SANITARY SEWER PROFILE  
PR-4

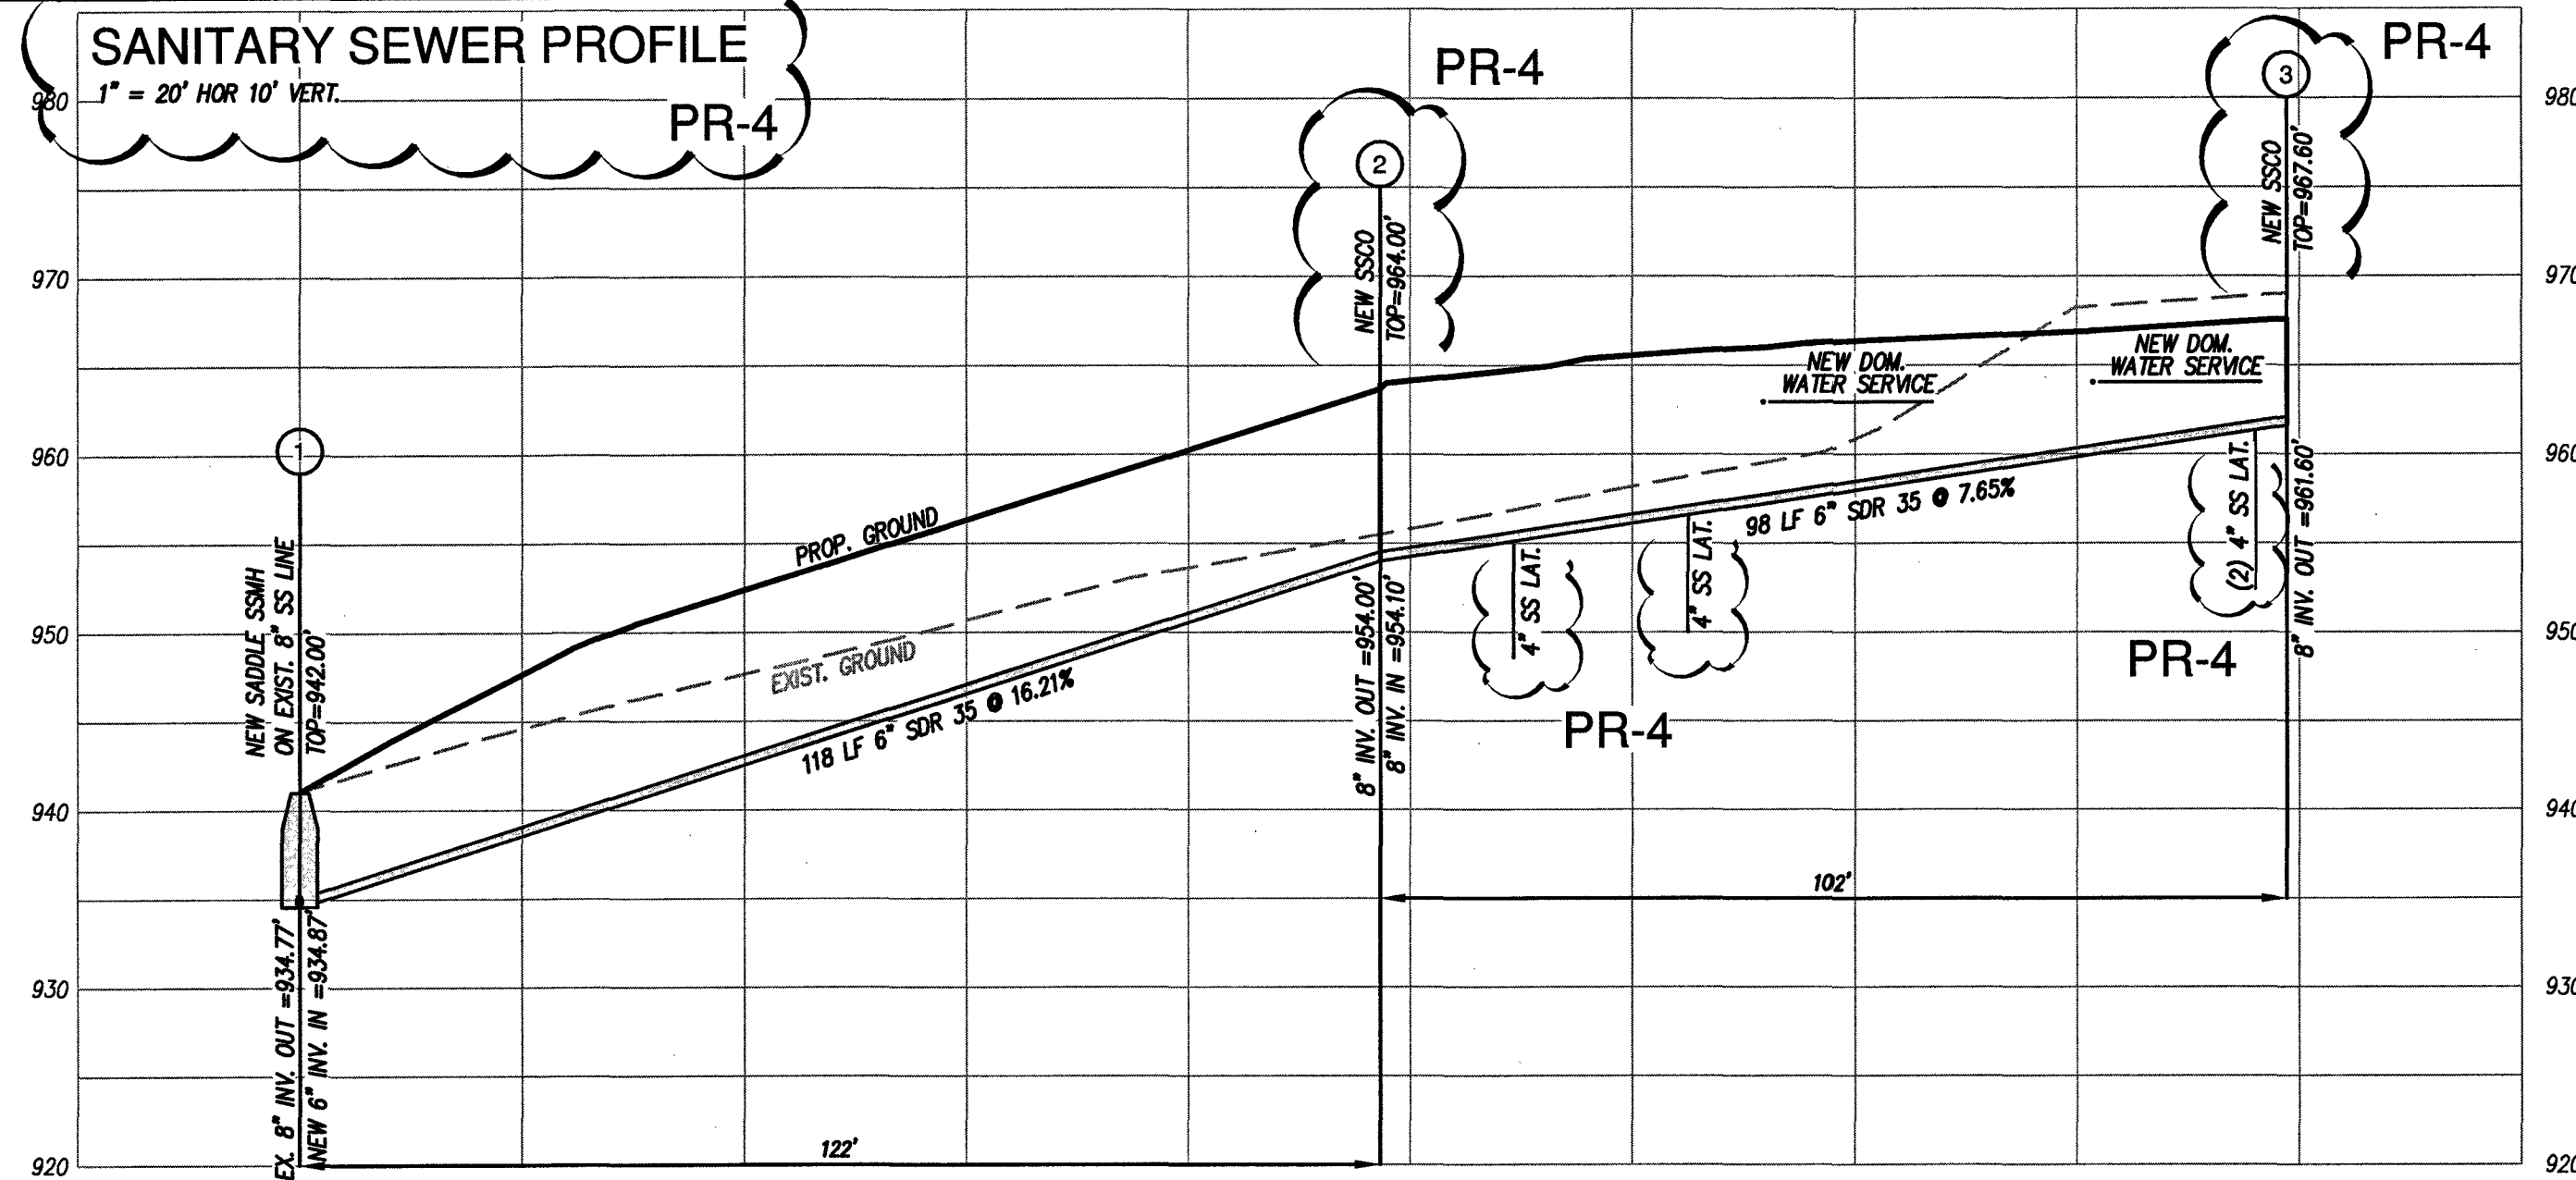
- REMOVED CDS UNIT FROM PLANS.
- INLET "DD" WAS REVISED TO A DI-1 & LOWERED.
- RELOCATED ALIGNMENT OF NEW SS (1) THRU (3) AND ASSOCIATED SS EASEMENT.
- REVISED WATER LINE SIZE FROM 6" TO 2".

WATERLINE PROFILE PR-2

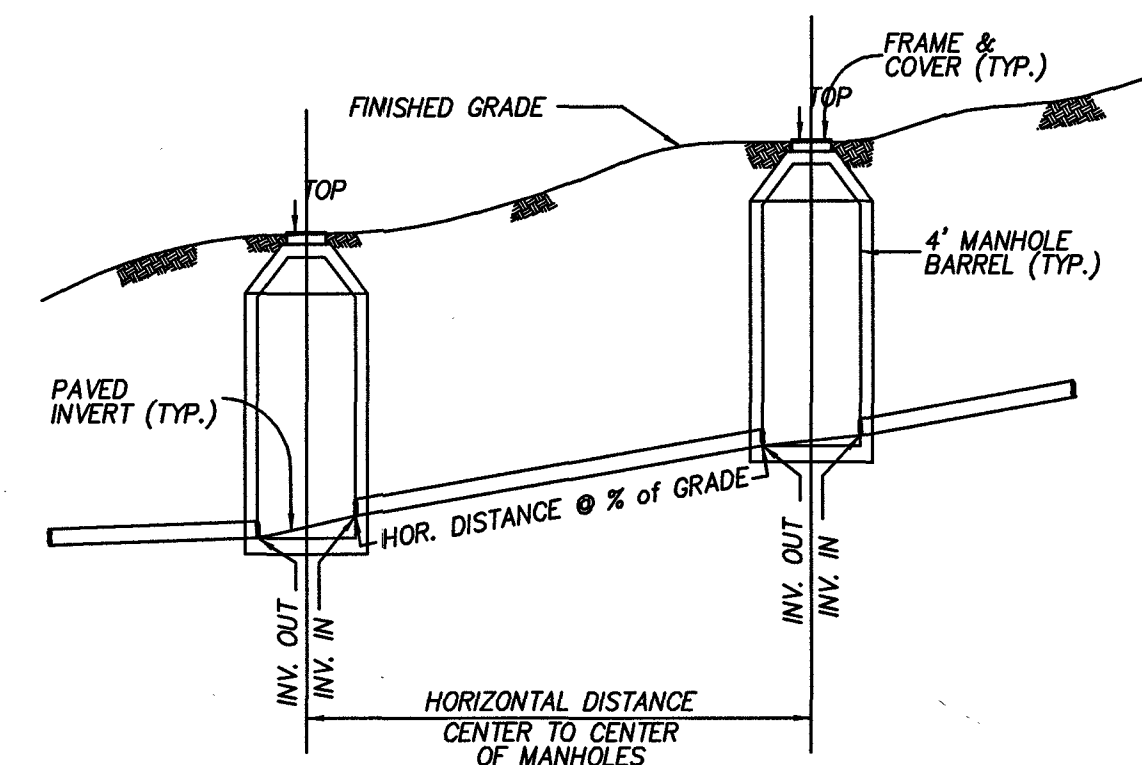
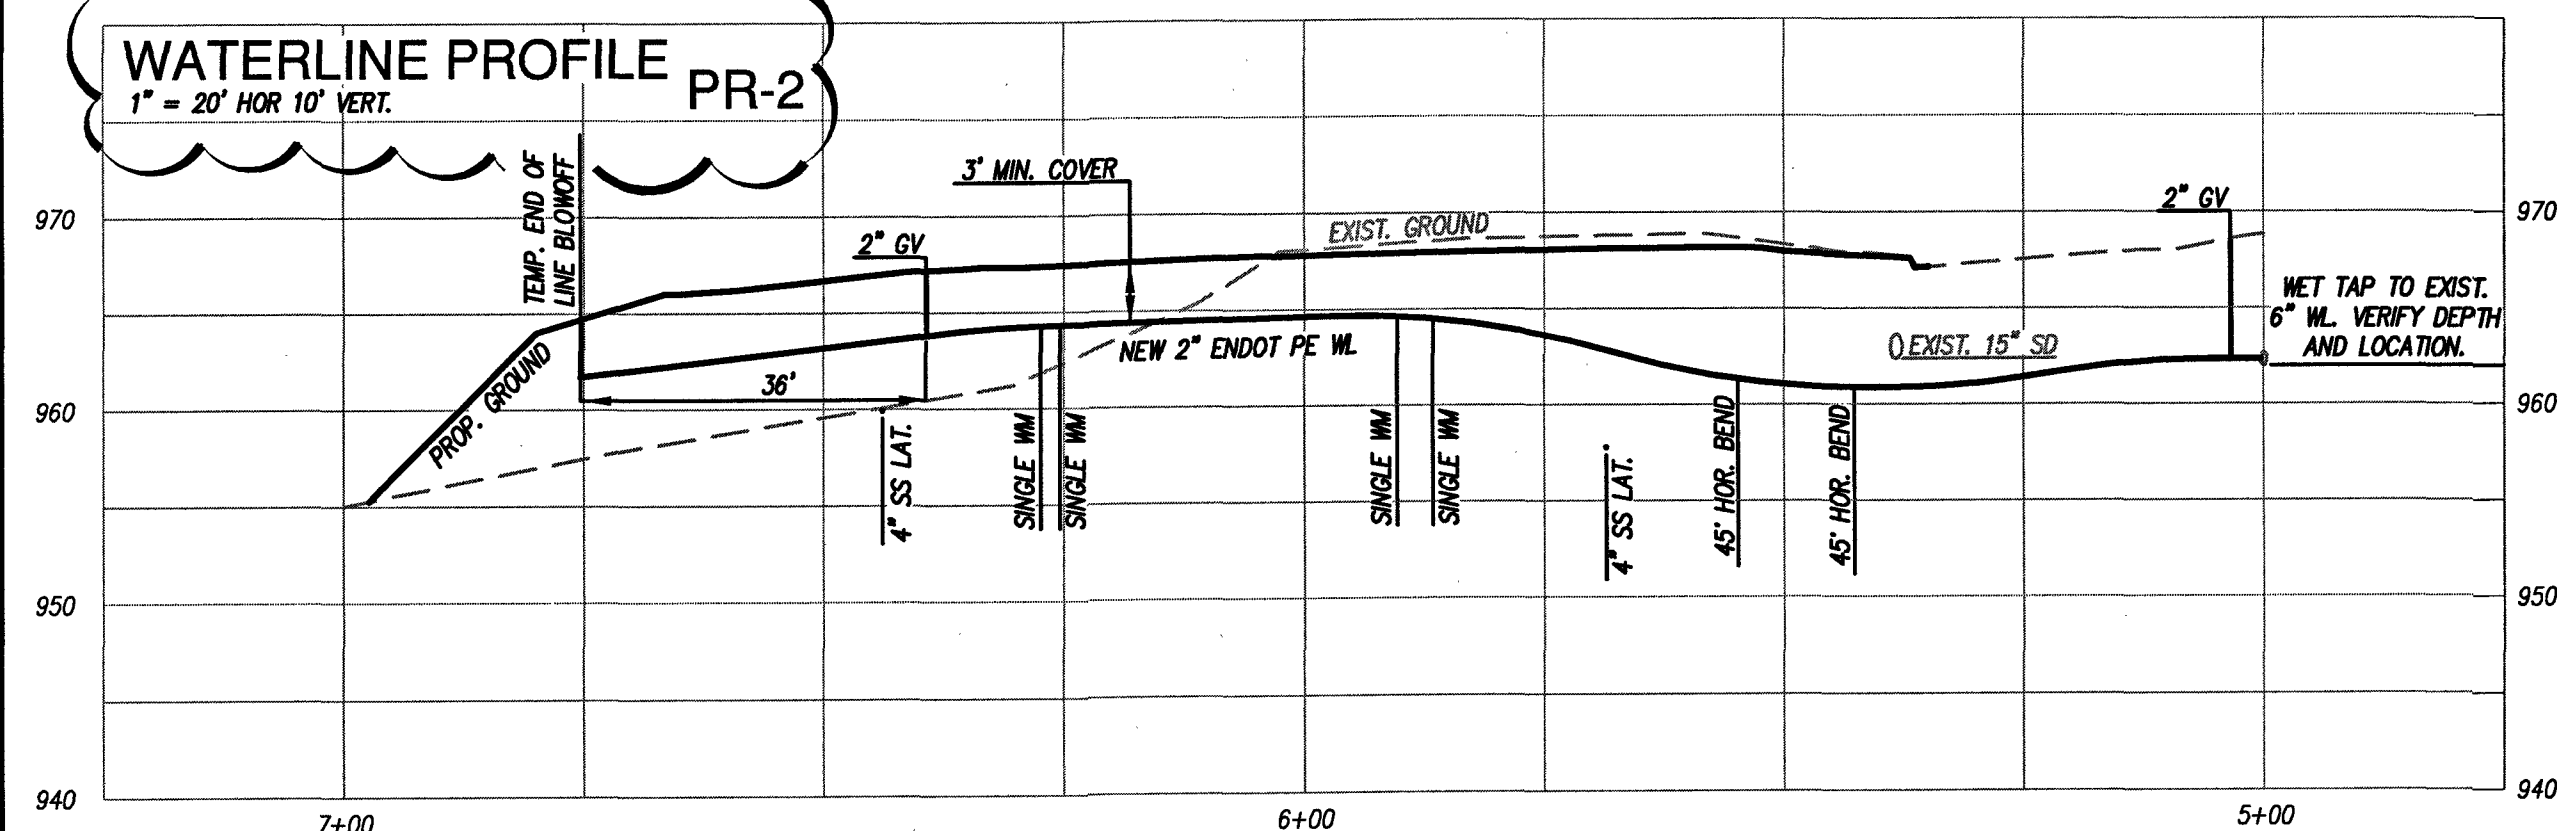
- RELOCATED BUILDINGS 9 & 10 WITH ASSOCIATED GRADING AND IMPROVEMENTS TEN FEET (10') TO THE WEST.
- RELOCATED ALIGNMENT OF NEW SS (1) THRU (3) AND ASSOCIATED SS EASEMENT.
- RELOCATED SD (BB) THRU (DD).
- EXTENDED WATER LINE TEN FEET (10') TO THE WEST.
